Product Change Notification

PCN-PCC-2801-2018

Business Unit	Product Line Code	Type of Change	Action	Date of Issue
PCC - PCB Connectors	AAA	Product Change Notification	Notify Distributors and Field	11/26/2018

Description for Product Change Notification

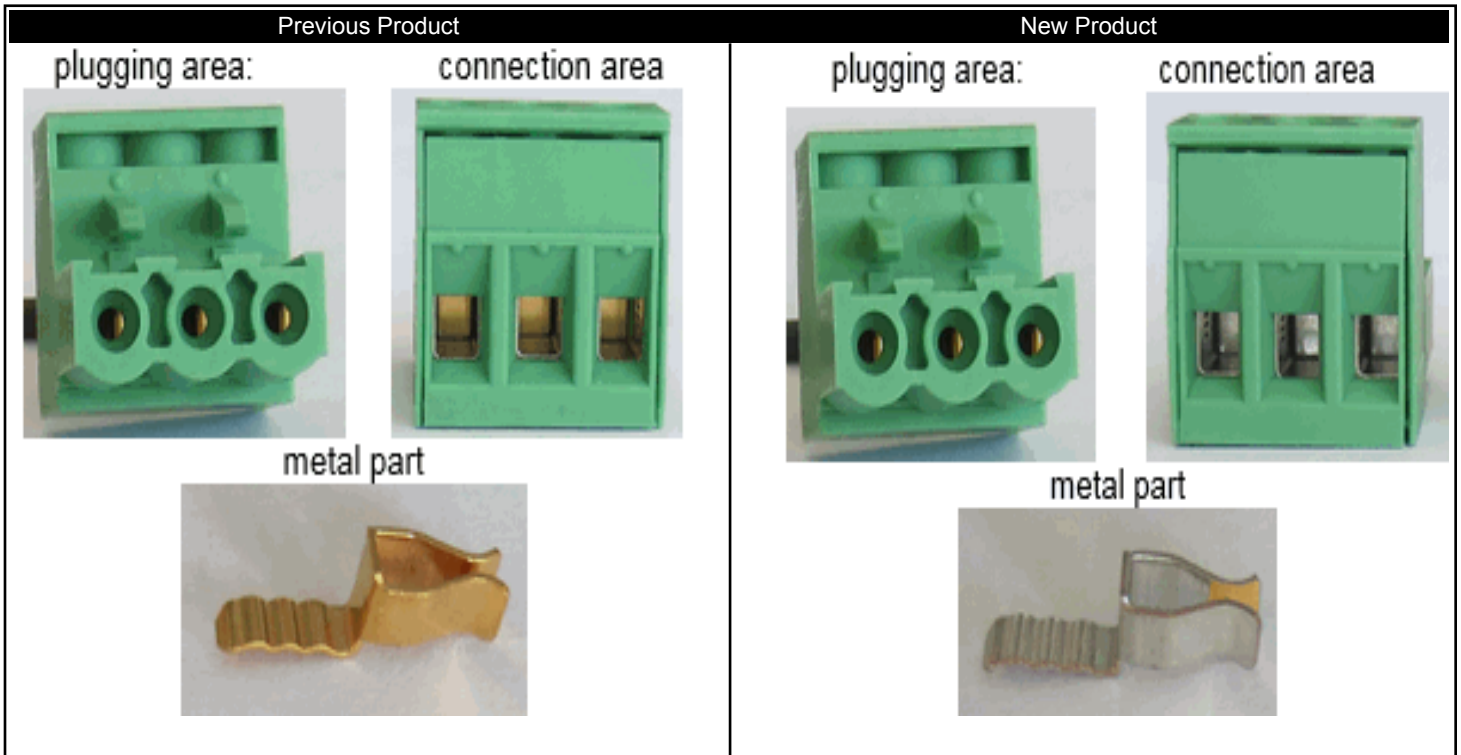
We will be changing the metal contact from a complete to a partially gold-plated surface for some of our connectors. This change will not increase the contact resistance, also dimensions and technical data will not be affected by this change. The revision level (V/C) will be updated per the attached spreadsheet. Initial delivery is expected to begin after January 1, 2019. During the conversion phase, both versions might be delivered depending on available local inventory.
